Determination 2011/080

The exercise of powers in respect of a notice to fix issued for a house at 859 Whangaparaoa Road, Whangaparaoa, Auckland

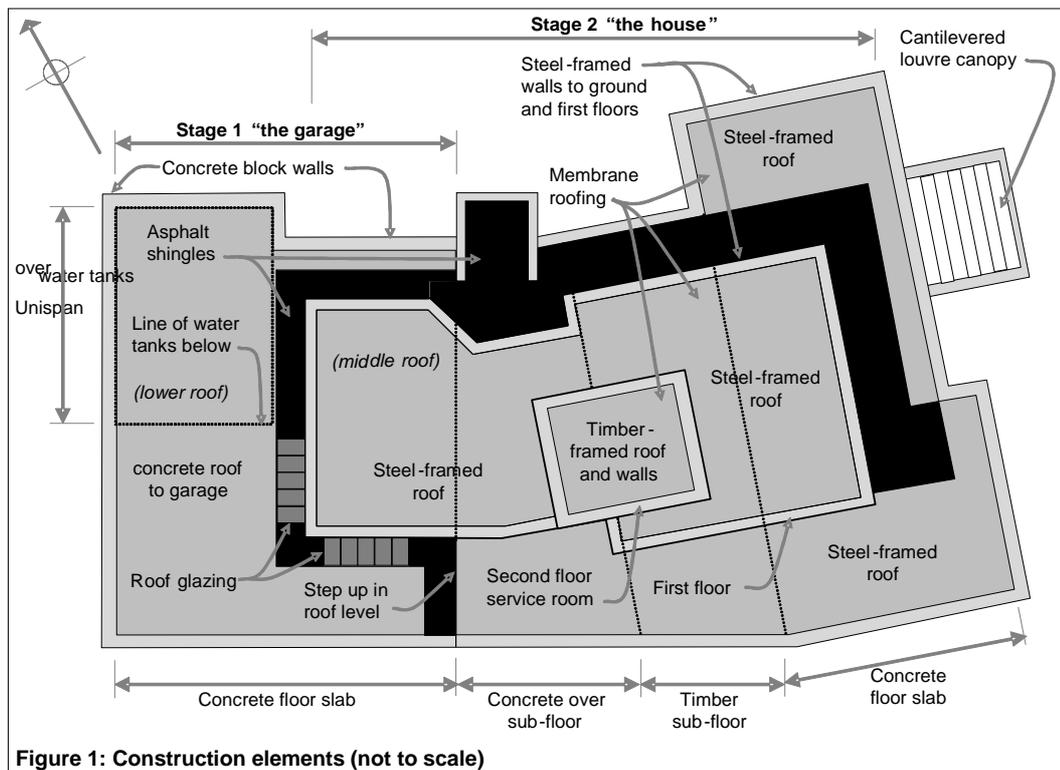
- 2.2 The building is two-storeys high in part and is made up of two main sections that were constructed in stages; a concrete garage structure ("the garage") and the remaining house structure ("the house"). The first floor level of the house extends partly over the garage roof and a small 'service room' is situated at second floor level. The construction is primarily comprised of specifically engineered elements, with some conventional light timber and steel frame as indicated in Figure 1.
